Reference: TWG Inter-Operability Problem Reports (IOPRs 40838, 40990, 41119)

Subject: Liaison Statement to IEEE 802.16 WG on modifications to the IEEE 802.16 standard needed to support WiMAX certification.

Annex A IOPR on General Clarifications on Ranging Regions (IOPR40990)

Figure 1: Illustration of data mapping rules.

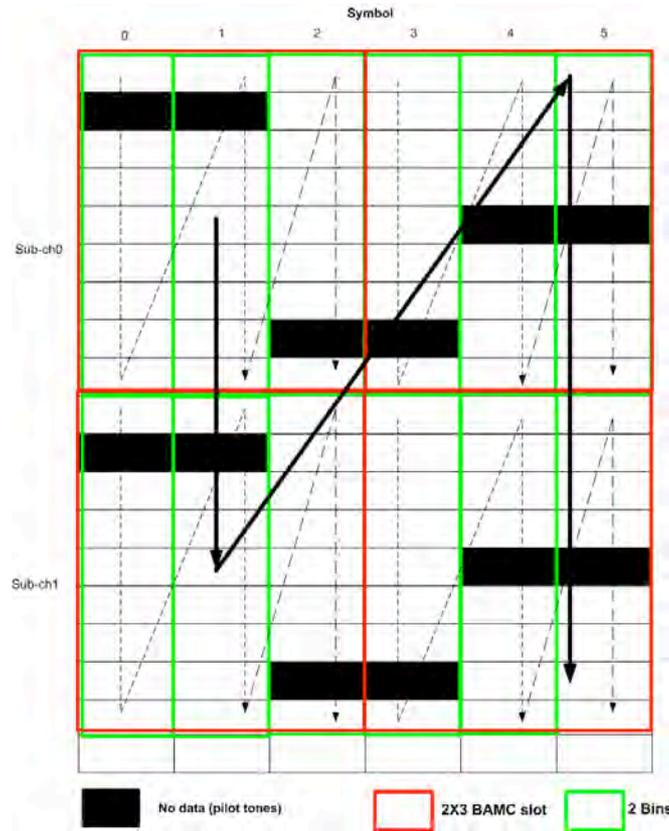
The section 8.4.8.3.1.2.1 in Rev2/D9 specifies the allocation of data subchannels for STC optional AMC in the following paragraph:

For 2-antenna matrix A in 8.4.8.3.3 the bursts are required to have 6 symbol granularity and begin on a 6 symbol boundary. In the first stage the data is first mapped frequency-first to each slot, and frequency-first over the slots of the allocation as depicted in Figure 219. Then at the second stage matrix A encoding is performed over each pair of QAM symbols which were assigned to the same subcarrier index over two symbols.

It is not perfectly clear what is meant by “bursts are required to have 6 symbol granularity and begin on a 6 symbol boundary”. Also, it is not perfectly clear if data mapping is on slot or slot-pair basis given the constraint about 6 symbol granularity. The explicit definition corroborated with illustration is required to avoid different interpretations from rather ambiguous text.

Modify the second paragraph in section 8.4.8.3.1.2.1 of Rev2/D9 as follows and add the figure:

For 2-antenna matrix A in 8.4.8.3.3 the bursts are required to have 6 symbol granularity and both begin and end on a multiple of 6 symbol boundary counting from the beginning of the zone. In the first stage the data is first mapped frequency-first to each slot, and frequency-first over the slots of the allocation as depicted in Figure 219. This implies that subchannels are allocated on slot by slot basis as indicated in Figure 1. As a result of the 6+6n symbol granularity required, all non-HARQ burst allocations and all HARQ sub-burst allocations of matrix A are rectangular. Then at the second stage matrix A encoding is performed over each pair of QAM symbols which were assigned to the same subcarrier index over two symbols. When 2-antenna matrix B is scheduled with 6+6n symbol per burst granularity (see section 11.8.3.5.5), the bursts are required to both begin and end on a multiple of 6 symbol boundary counting from the beginning of the zone. In case of matrix B with 6+6n symbol per burst granularity, all non-HARQ burst allocations and all HARQ sub-burst allocations are rectangular.
